A47 Wansford to Sutton Dualling

Appendix 13.2 – Drainage strategy report

ENVIRONMENTAL STATEMENT APPENDICES
Appendix 13.2 – Drainage Strategy Report

Regulation Number:	Regulation 5(2)(a)
Planning Inspectorate Scheme Reference	TR010039
Application Document Reference	TR010039/APP/6.3
BIM Document Reference	HE551494-GTY-HDG-000-RP-CD-00001-C01
Author:	A47 Wansford to Sutton Project Team, Highways England

DRAINAGE LAYOUT PLAN
SHEET 3 OF 7

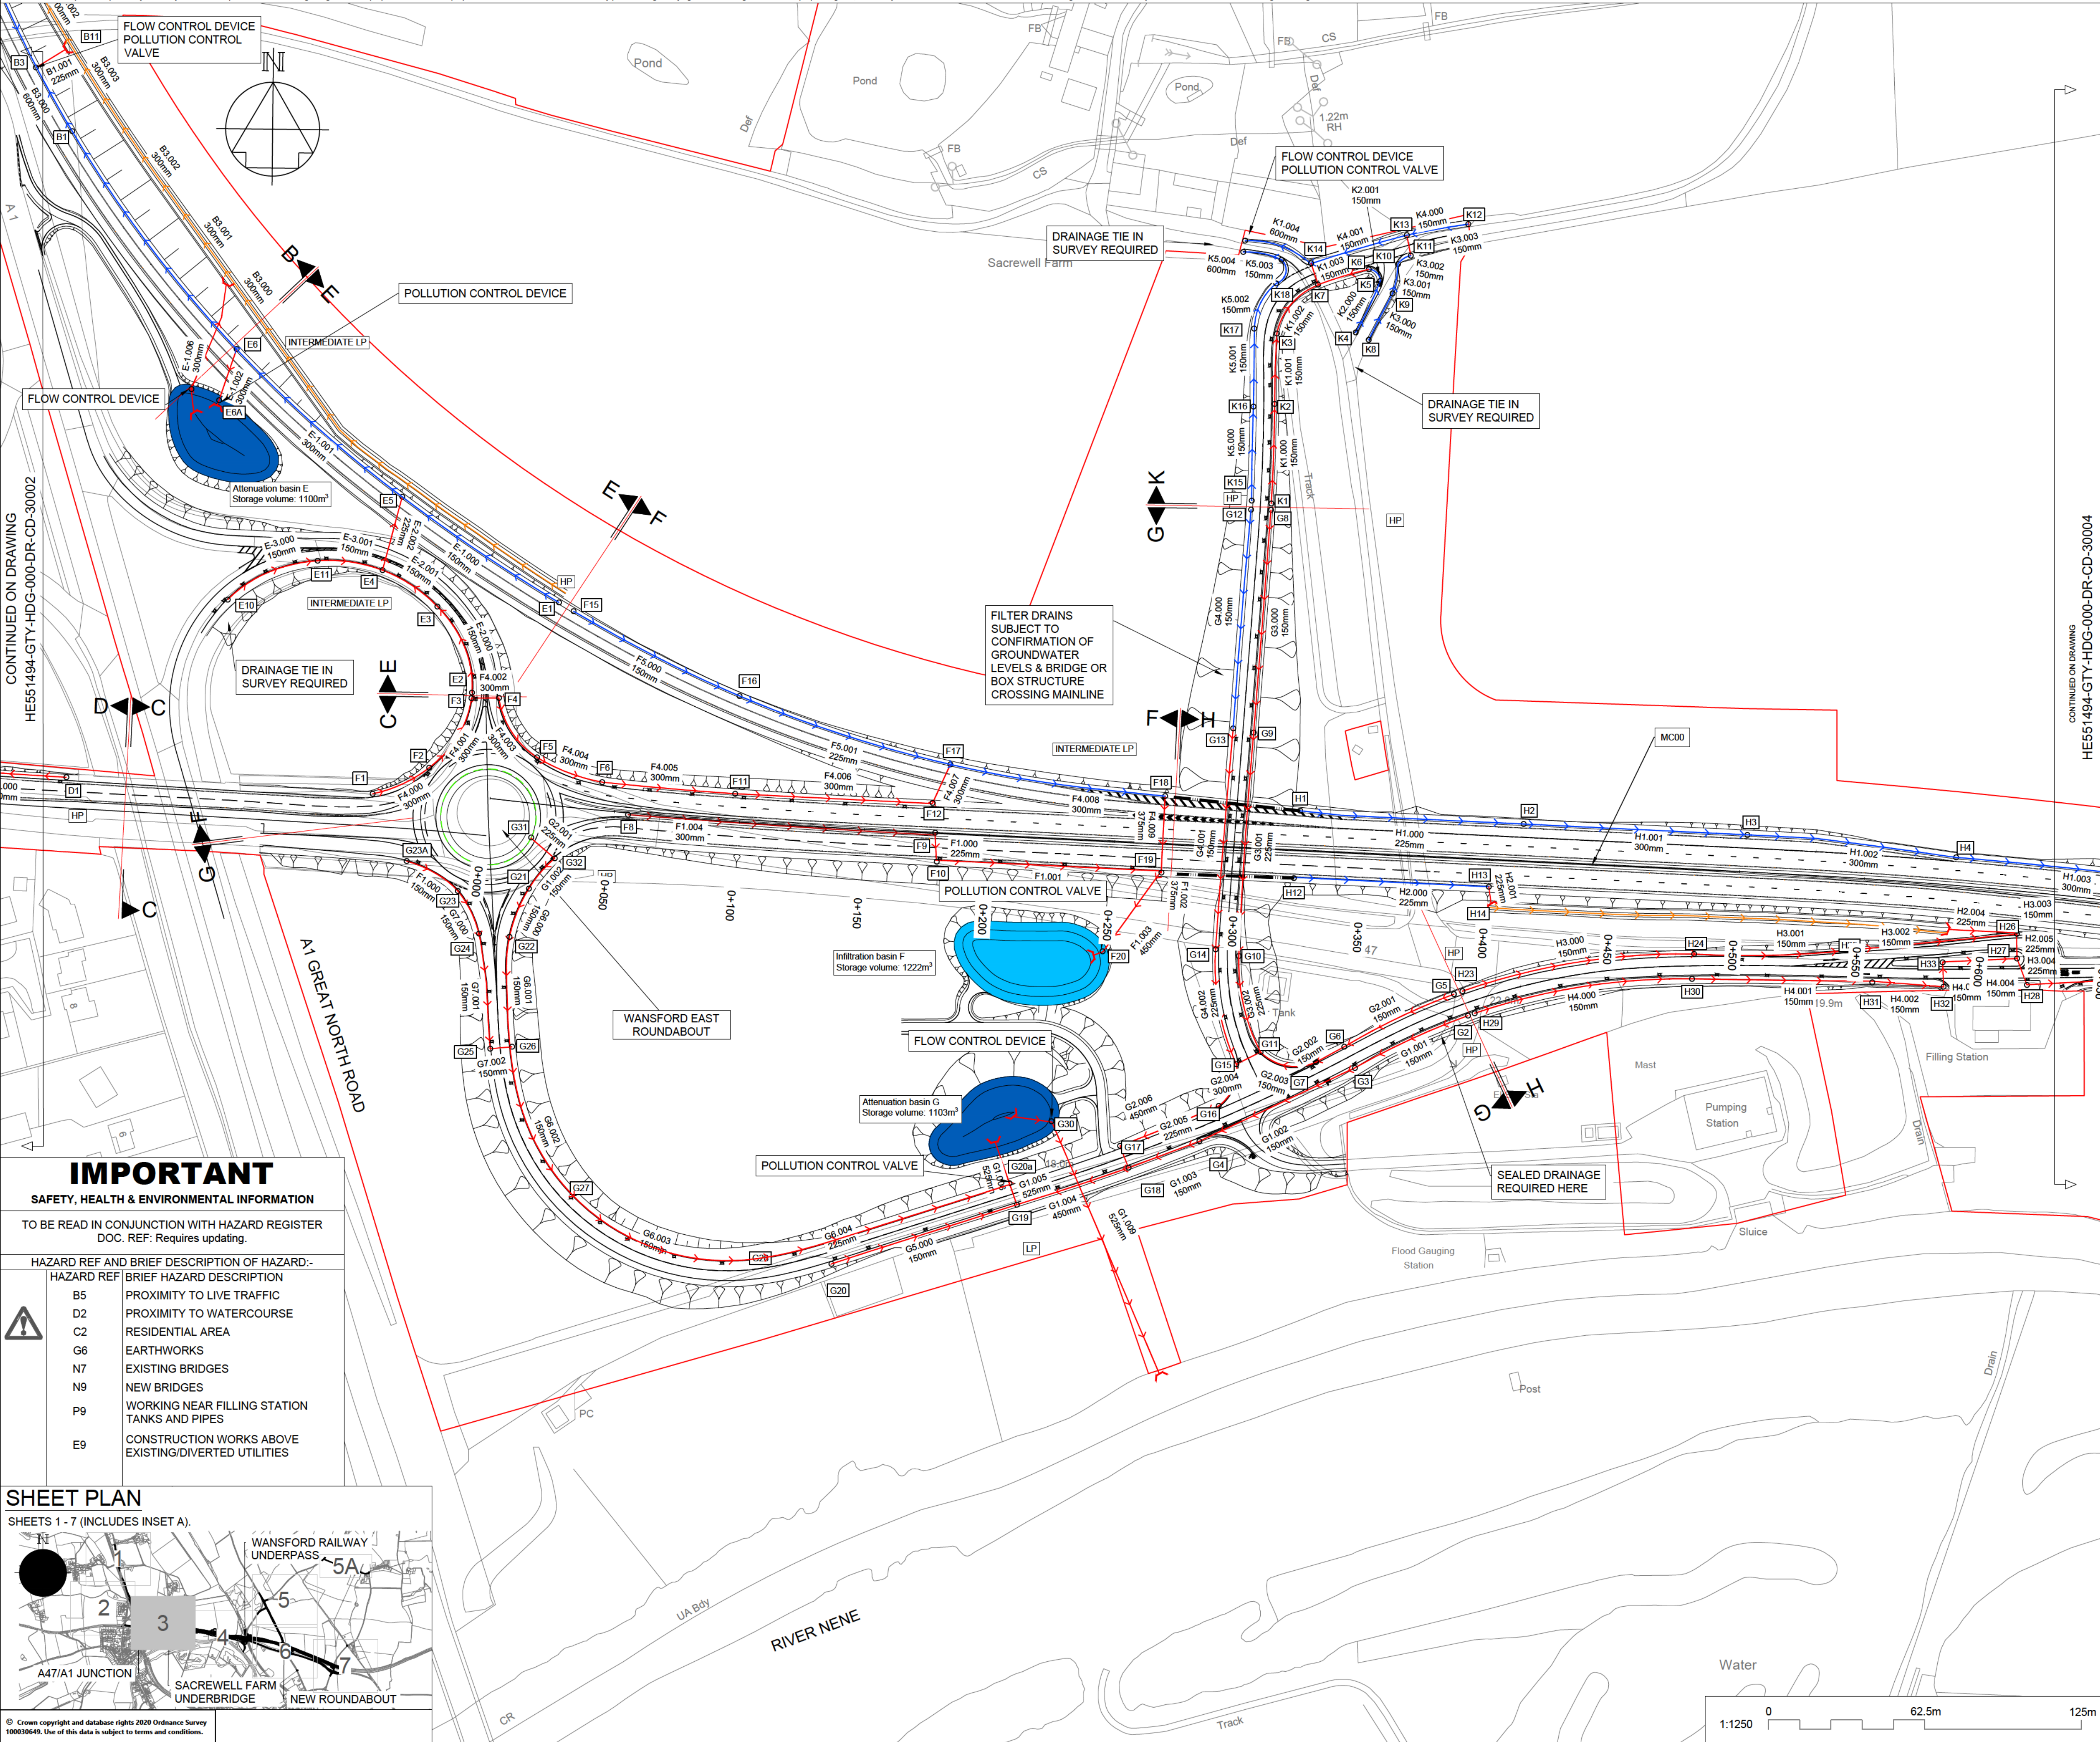
Sheet 3

6. Network F - it appears from the drawing that the kerb drain system that serves the roundabout does not have a connection to the rest of network F. Should this be amended it would be logical to connect this to network G (F23 to G23 and F24 to G21).

DRAINAGE LAYOUT PLAN
SHEET 5 OF 7

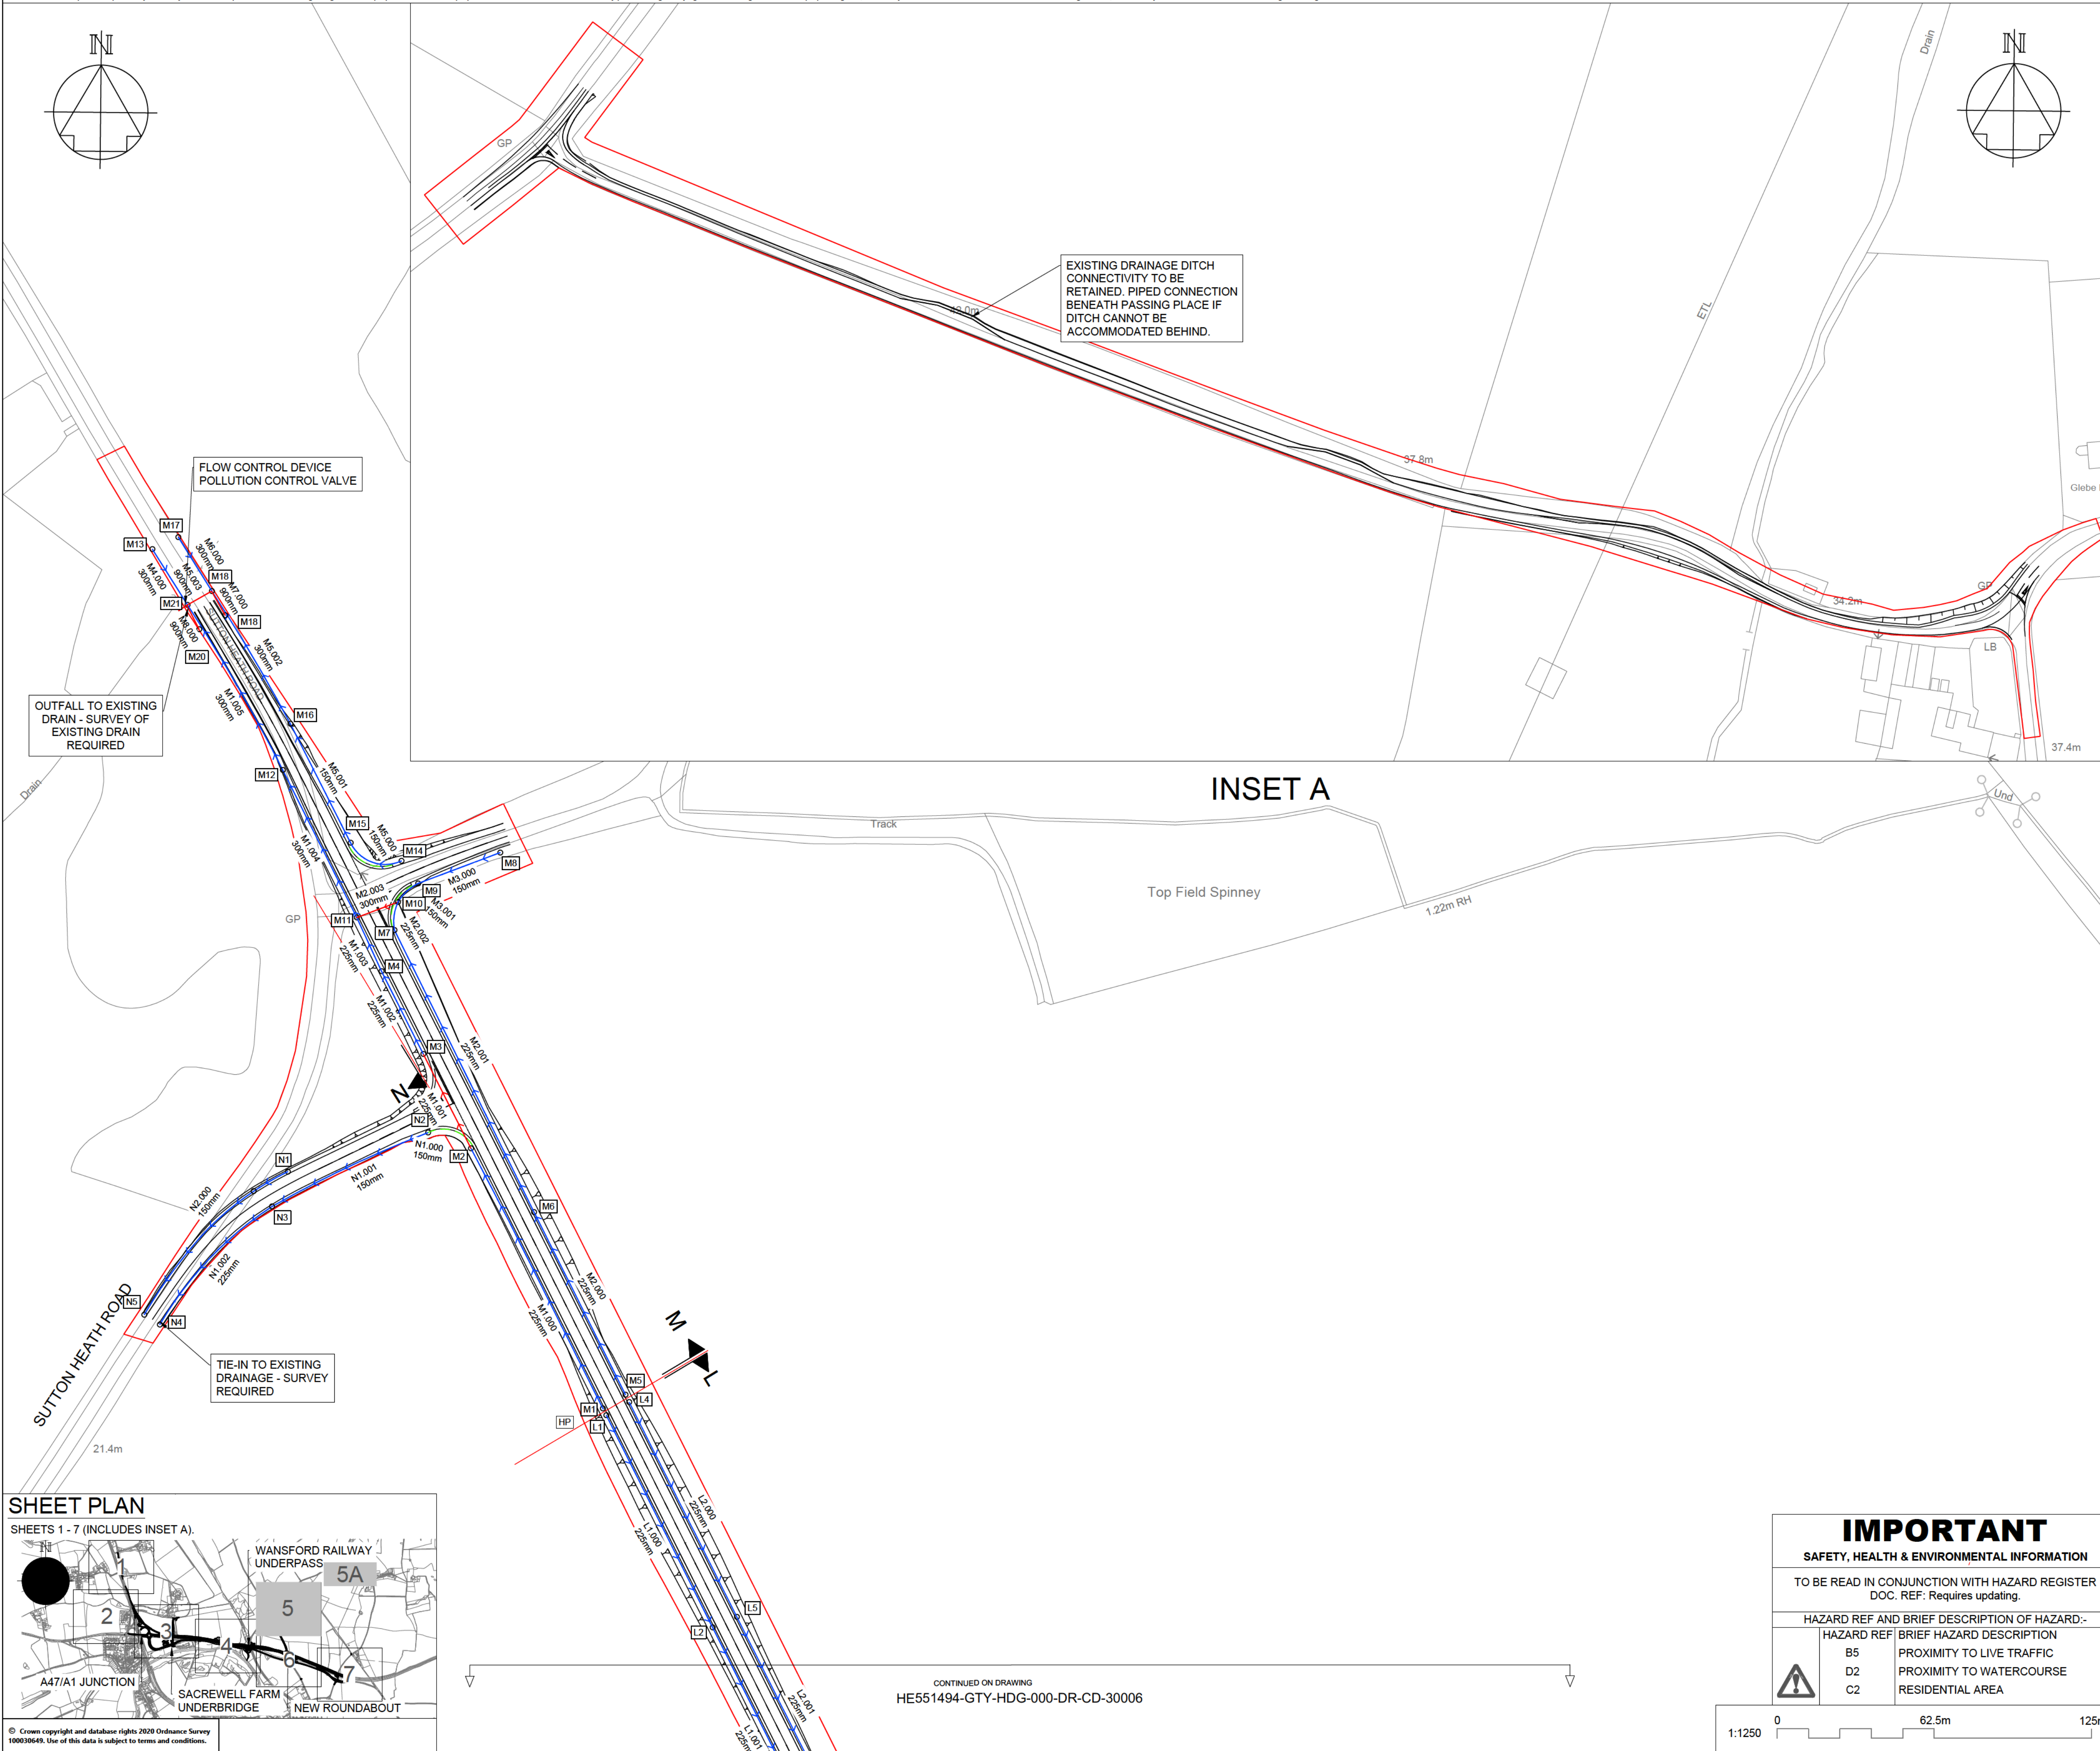
Sheet 5

1. Network M - In relation to the proposed outfall at manhole M21, as we understand it this existing drain is in a poor condition / now non-existent due to cattle occupying the adjacent field. As such we would be cautious of a positive system discharging into said ditch. As stated on the drawing a drainage survey will be required.
2. Network N - In relation to the proposed outfall at manhole N4, a drainage survey is required as we are not aware of any existing positive drainage system on Sutton Heath Road.
